City of Mississauga Department Comments

Date Finalized: 2022-04-20	File(s): A206.22 Ward 8
To: Committee of Adjustment	
From: Committee of Adjustment Coordinator	Meeting date:2022-04-28 1:00:00 PM

Property Address: 3471 Chartrand Cres

The applicant is proposing a below grade entrance requiring a variance for a setback.

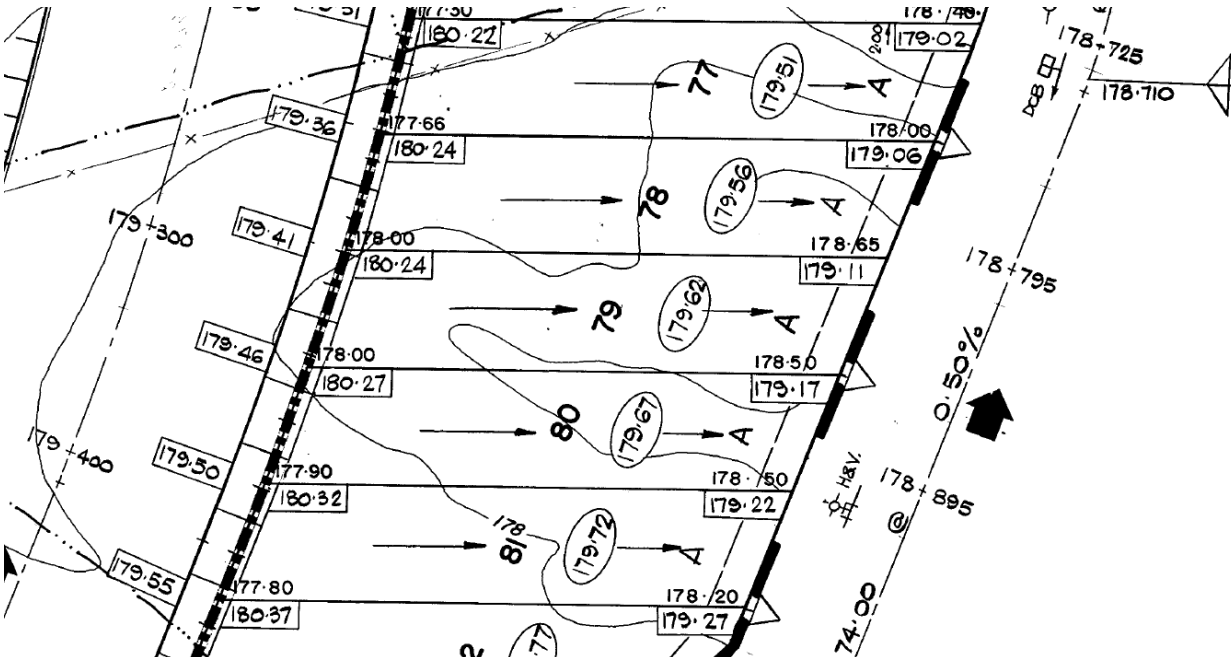
Enclosed you will find pictures of the side yard area where the below grade entrance is proposed. You will also find an excerpt from the Subdivision Lot Grading Plan (C-23095) which was prepared by Proctor and Redfern Consulting Engineers for the original subdivision design. You will clearly see from the excerpt that this particular lot was designed to be a 'back to front' draining lot, meaning that all the surface drainage from the rear yard is directed to the street via the side yard swales. The proposal for a basement entrance in the side yard will eliminate the space required for the swale and therefore redirecting the surface drainage onto the neighbouring lot.

The first photo is the area where the basement entrance is proposed. In the second photo, you will also notice that on the other side of the dwelling, there is structure attached to the side wall. We question how the applicant can safely access the rear yard without having to encroach onto the neighbouring lots to access the rear yard.
